CHANGE ORDER

PROJECT NAME: Edward A. Dufresne Community Center CHANGE ORDER NO: 002 (Final)

PPG OCD-DR PROJECT NUMBER: 45PARA3201

Work Changes Proposal Request

Project number: 21131.00
 date: 01-21-13
 file name: ASK011.dwg
 issued for: WCP R 010
 this drawing modifies: A201

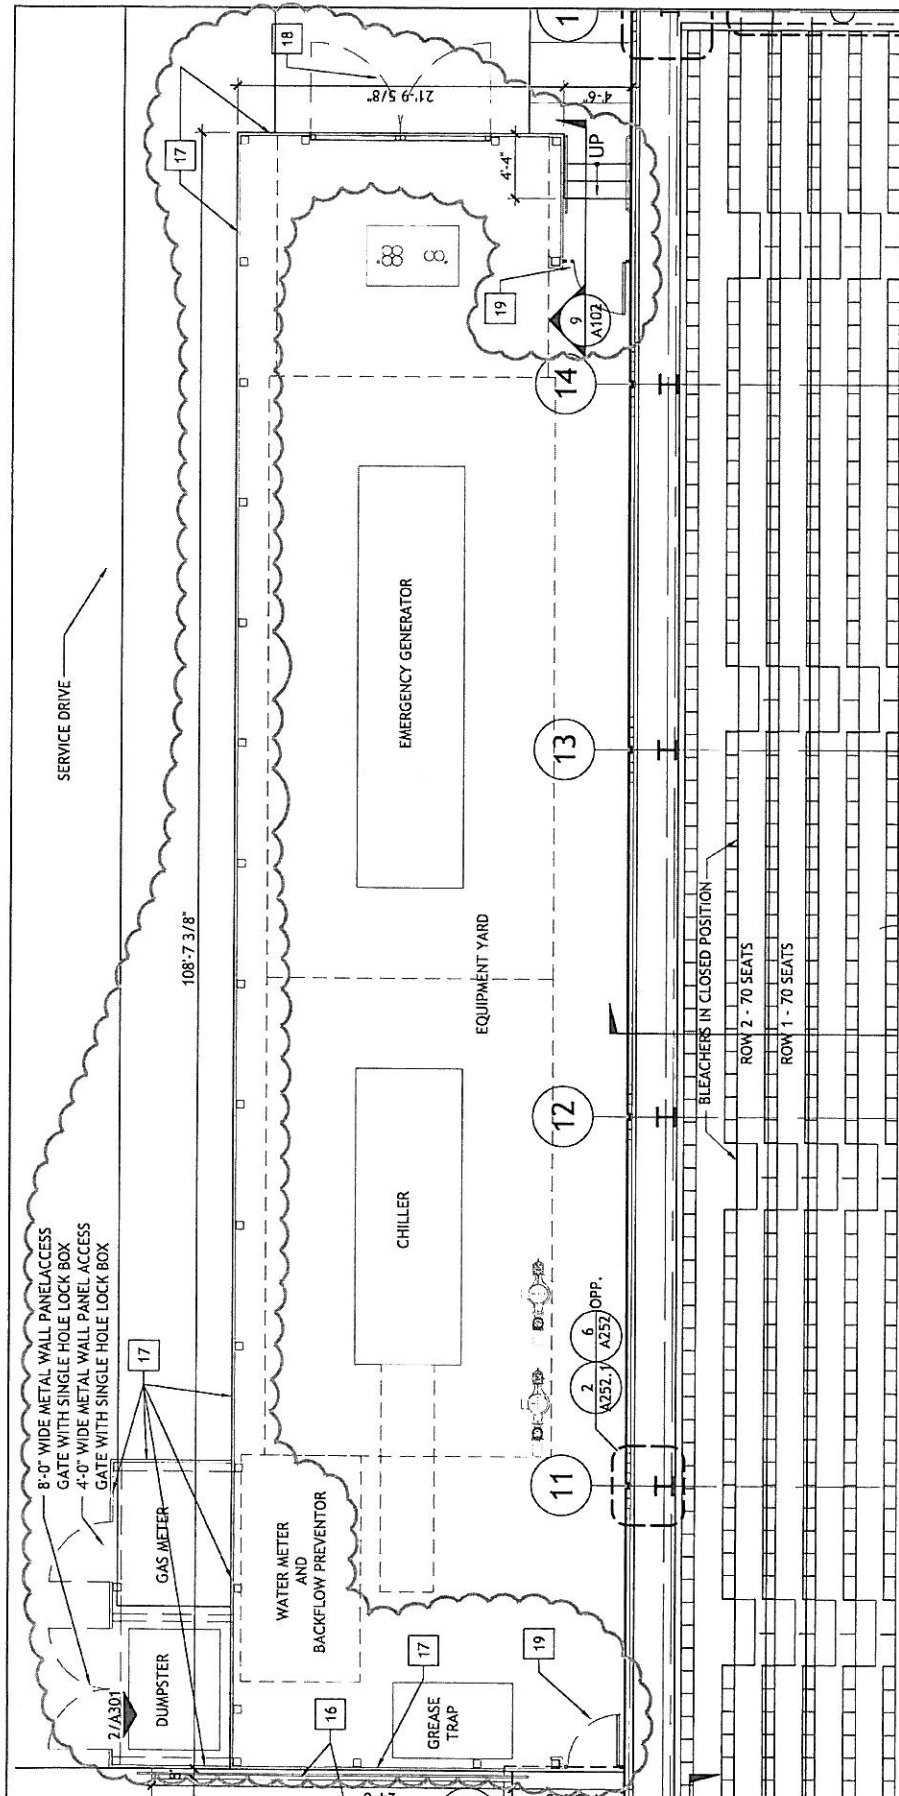
1. Provide credit for 8'-0" high chain link fence around perimeter of Equipment Yard and 8'-0" high wood fence around dumpster & gas meter.
2. Provide quote to supply and install corrugated fence around perimeter of Equipment Yard, Dumpster area and Gas meter area as detailed on attached sketches.

| 3 | FLOOR RECESSED VOLLEYBALL SLEEVE - ALTERNATE NO. 2, SEE 5/A710 | 17 | 9'-0" HIGH METAL-WALL PANEL FENCE AROUND PERIMETER OF EQUIPMENT YARD |
| 4 | RETRACTABLE BLEACHERS - SEE 1 / A710 | 18 | (2) 6'-0" WIDE METAL WALL PANEL ACCESS GATES WITH SINGLE HOLE LOCK BOX |
| 5 | RECESSED FLOOR OUTLET - BASE BID SEE 3 / A710 | 19 | 42" WIDE METAL PICKET ACCESS GATE W/ DEADBOLT |
